Large-Scale Residential Development at Ballybin Road, Ratoath, Co. Meath

Applicant's Response to LRD Opinion
Items 4(b), 5, 6, 10, 11, 13 and 19
(Planning Submission)

2334-DOB-XX-SI-RP-C-0005

June 2024

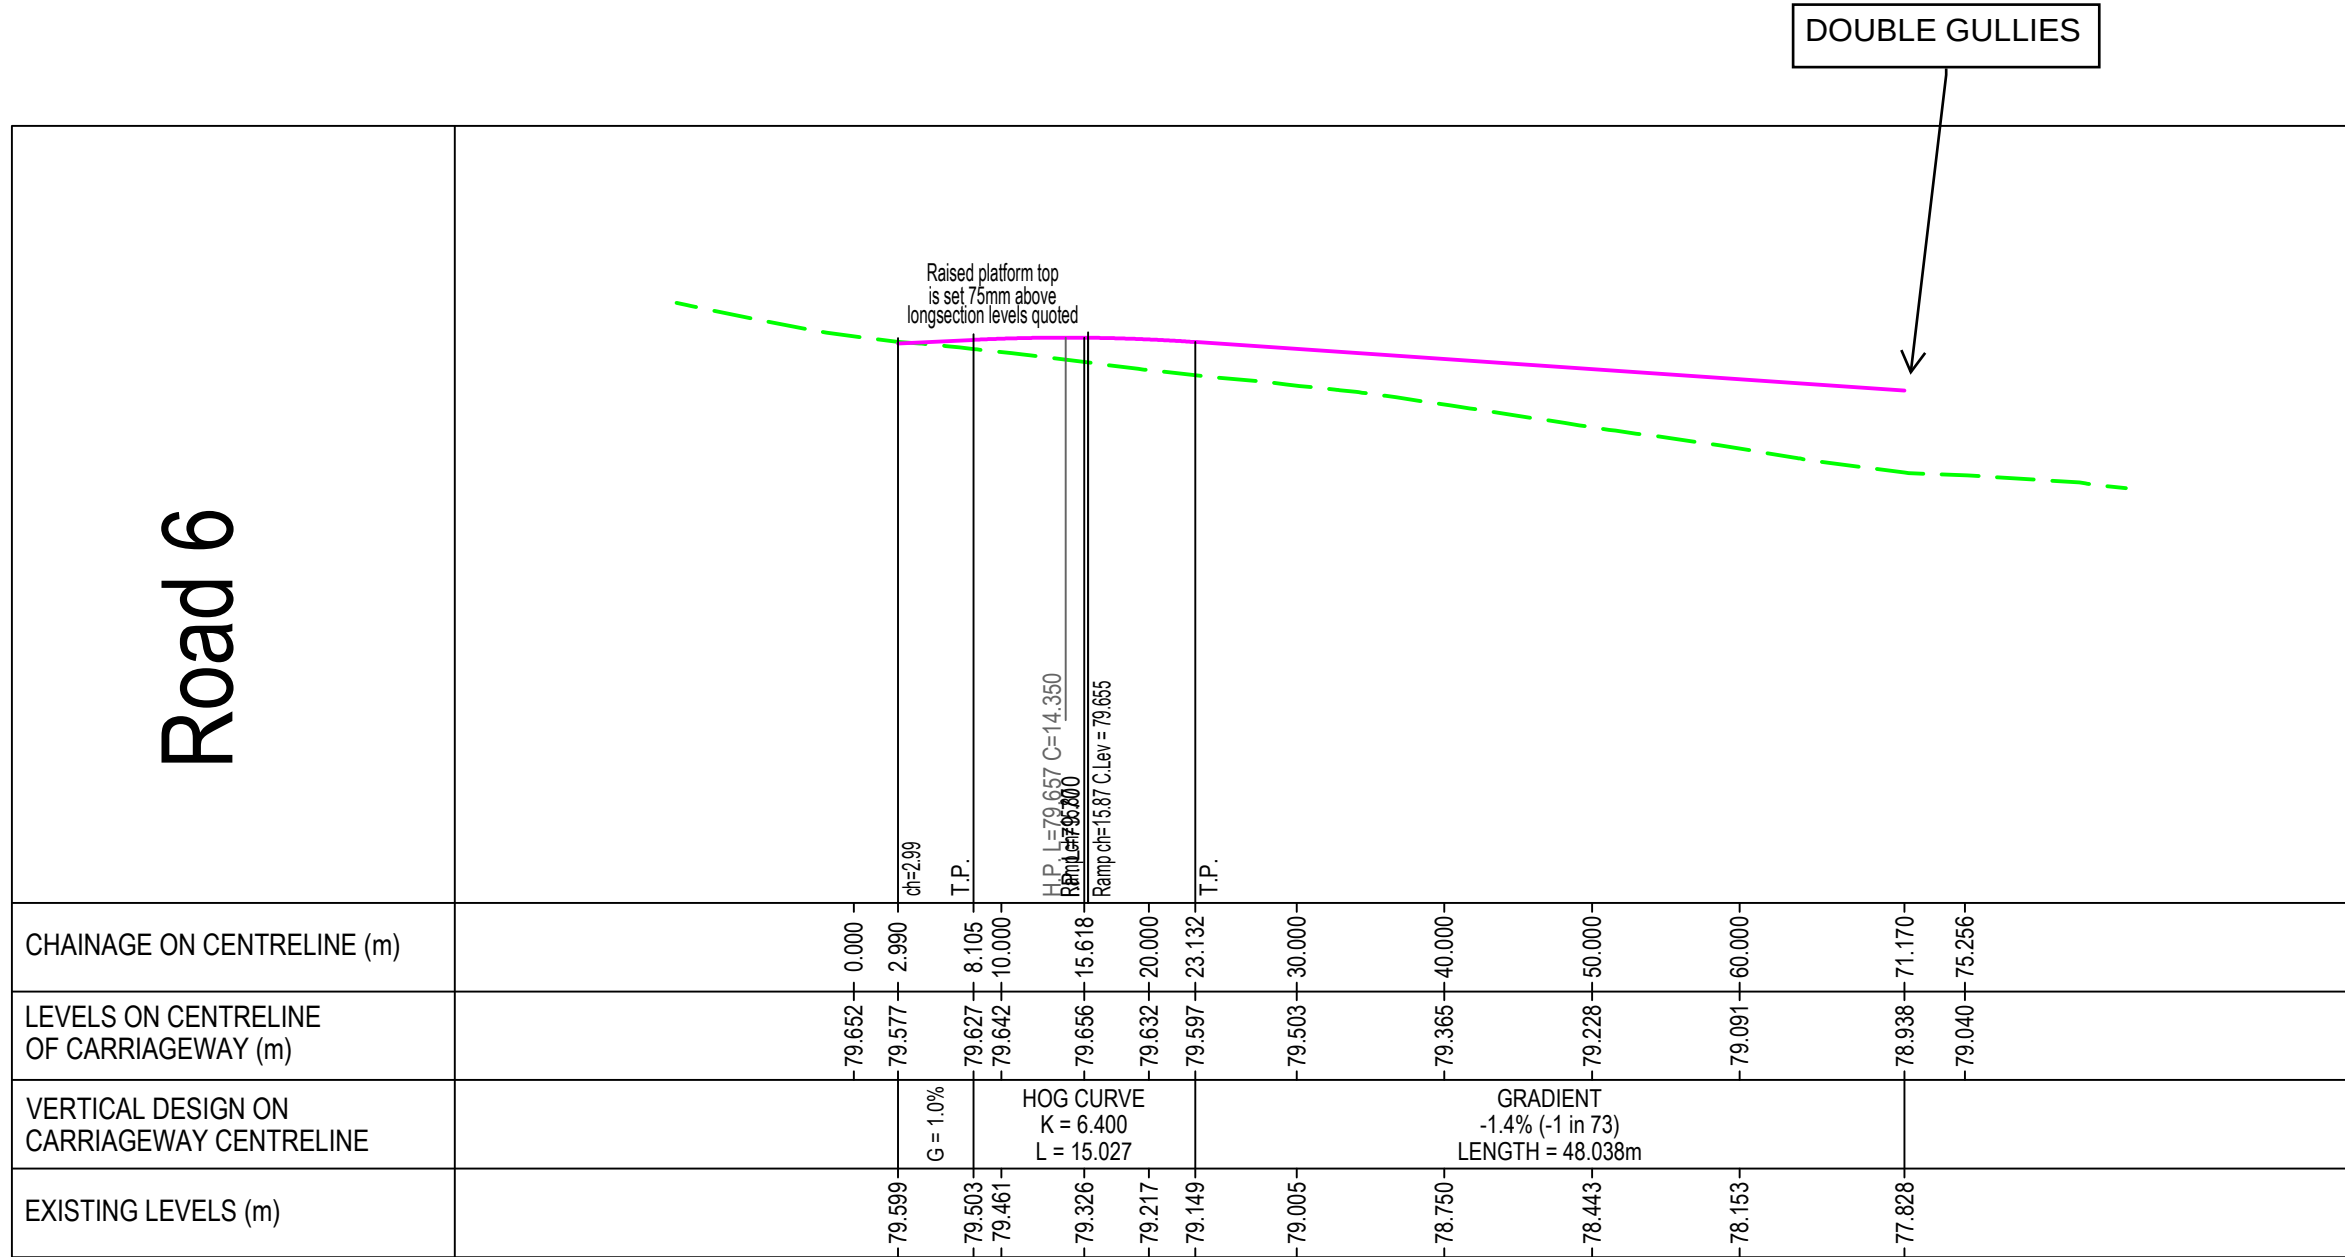
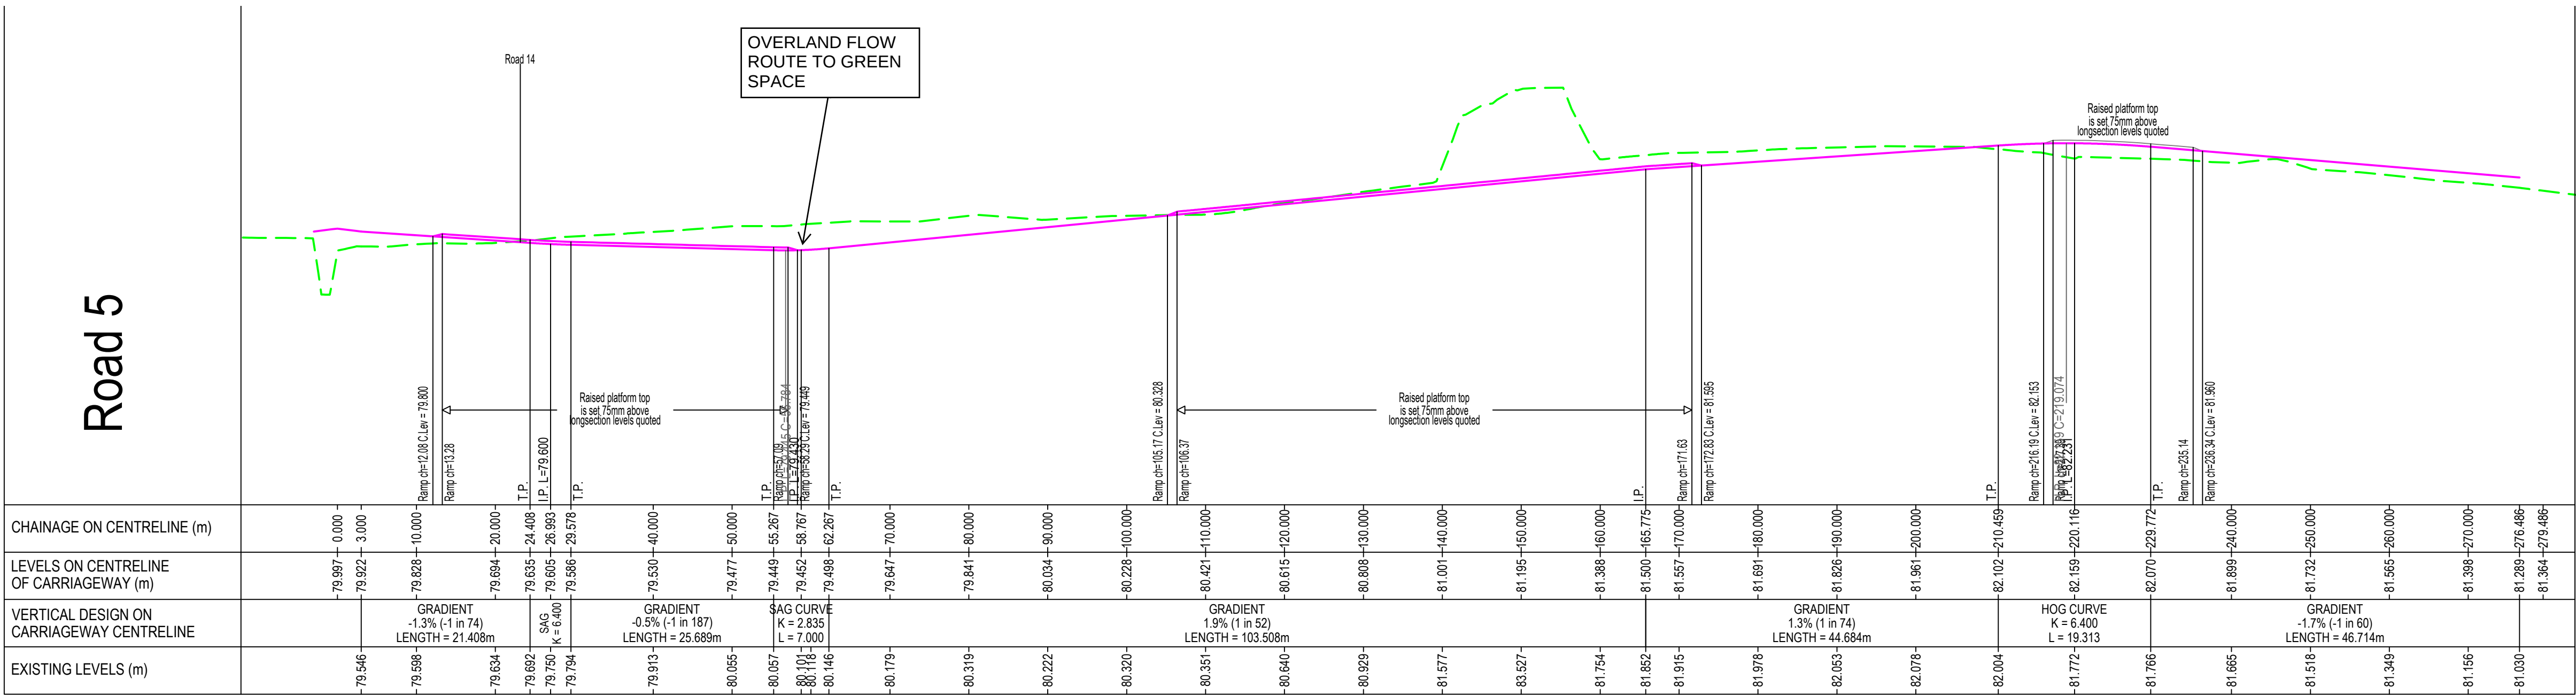
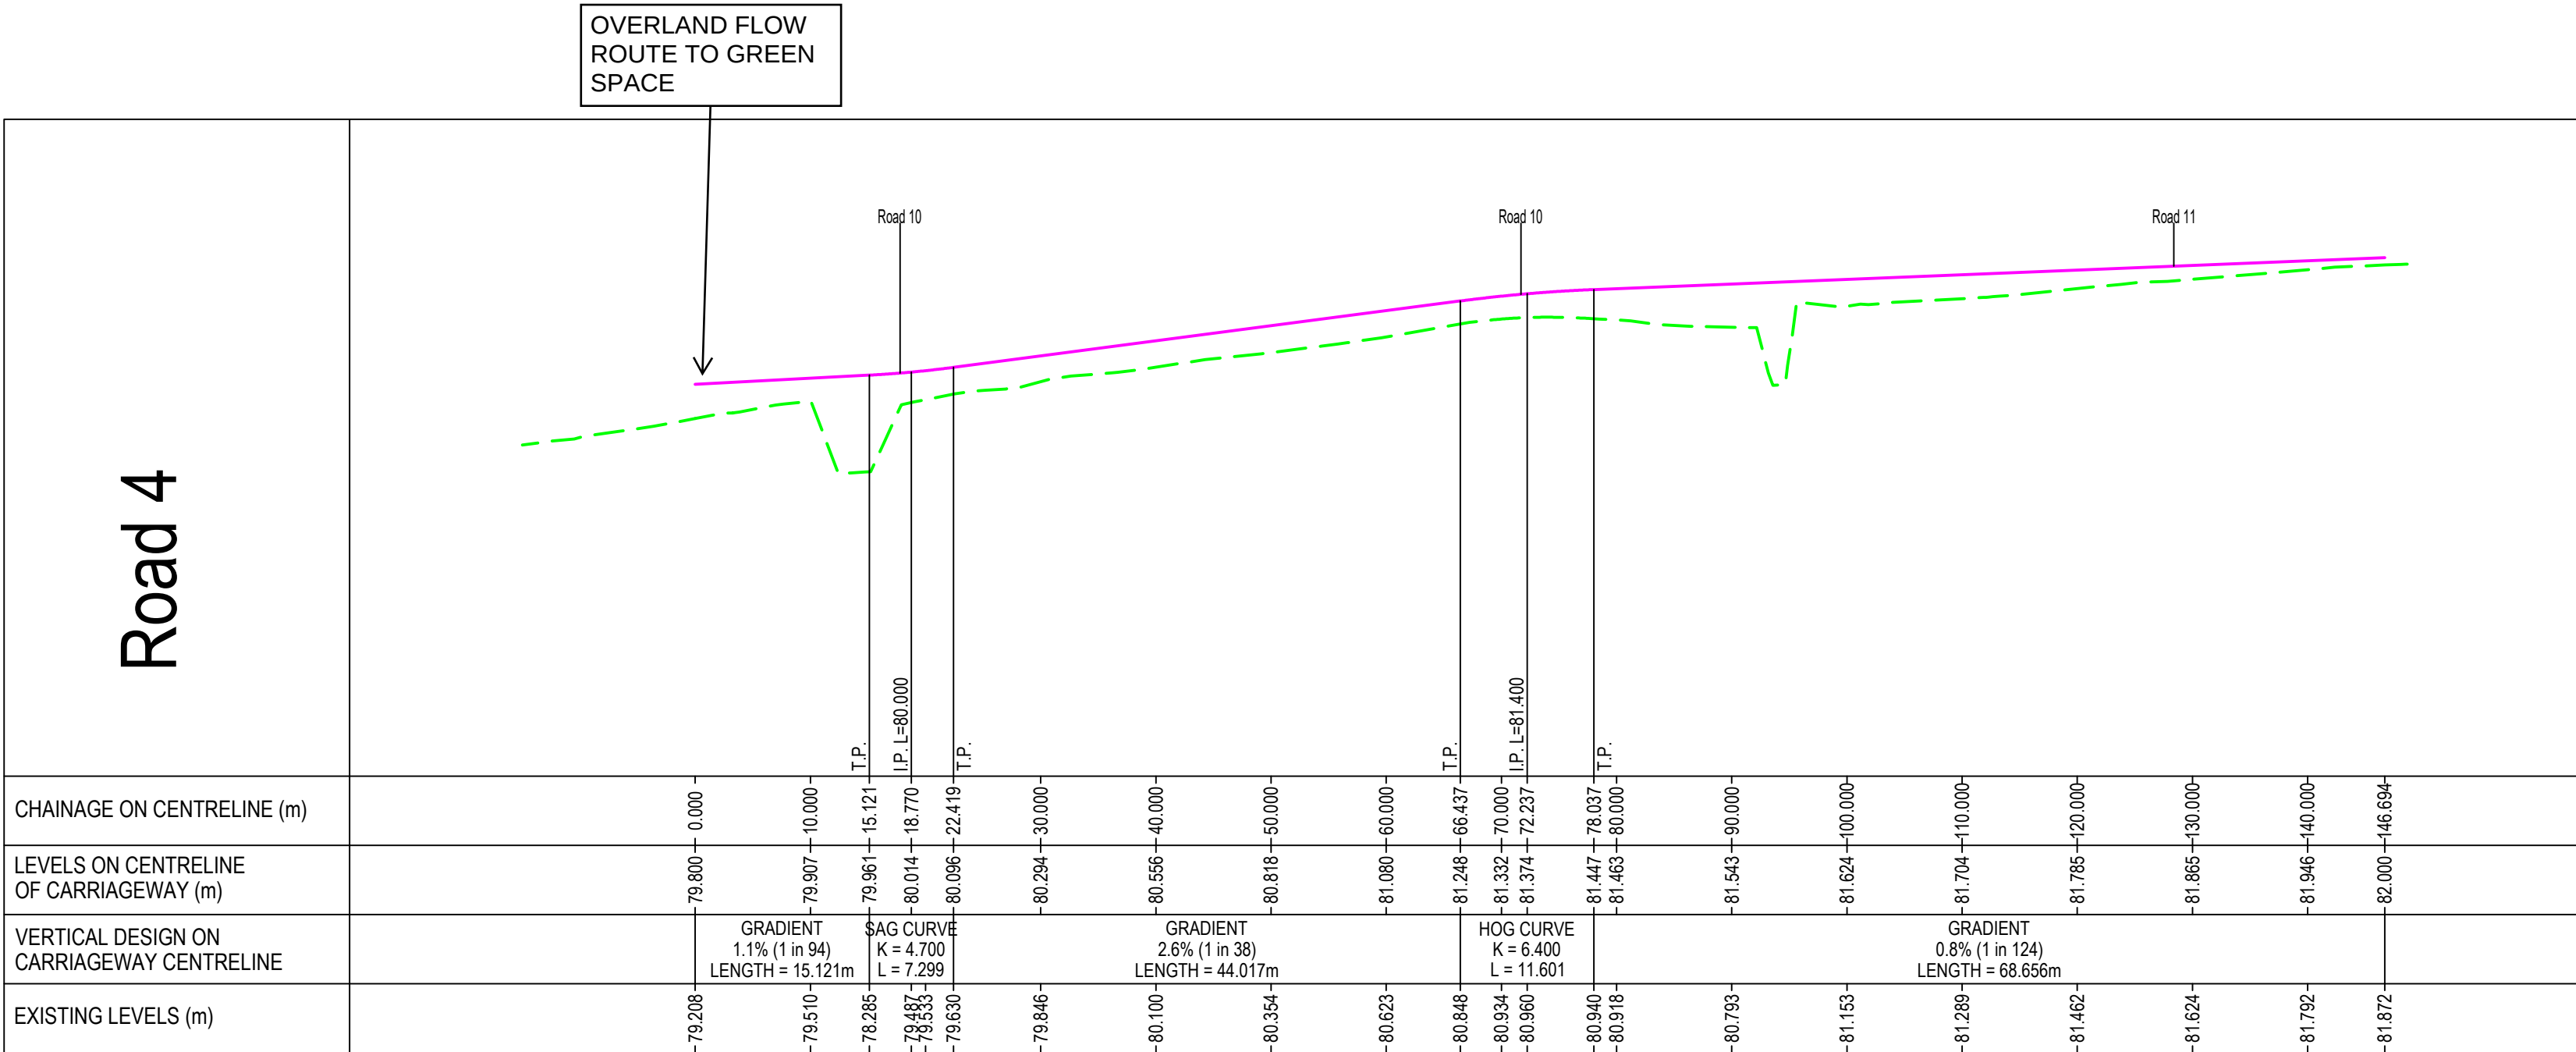
The applicant shall provide confirmation of the catchment area of the adjacent public road and provide details of the sizing of the attenuation system for same.

The proposed attenuation systems detail to be agreed with the Environment Department. It was noted that the proposed attenuation system beside the proposed creche had a potential depth of 1m of water during the 1 in 100-year rainfall event. Max depth of water to be 300mm during the 1 in 100-Impermeable year rainfall event.

The DOBA drawings 2334-DOB-XX-SI-DR-C-0200, 0201 and 0202 submitted under separate cover with the Planning Application documentation illustrate the sub-catchment areas of the adjacent public road. The sizing of the attenuation associated with each sub-catchment is also illustrated on these drawings.

The Applicant would welcome a condition to agree the attenuation system details with the Environment Department post grant of planning. Additionally, the Applicant notes that the design of the proposed scheme has developed since the LRD Opinion meeting and the inclusion of a creche no

longer forms part of the proposals. The updated surface water drainage design includes a maximum 300mm depth of water, not 1.0m, in the deepest detention basin for a 1:100-year storm event including climate change. Please refer to the Surface Water Calculations appended to the DOBA Infrastructure Design Report (IDR) namely 2334-DOB-XX-SI-RP-C-0001 submitted under separate cover with the Planning Application documentation.
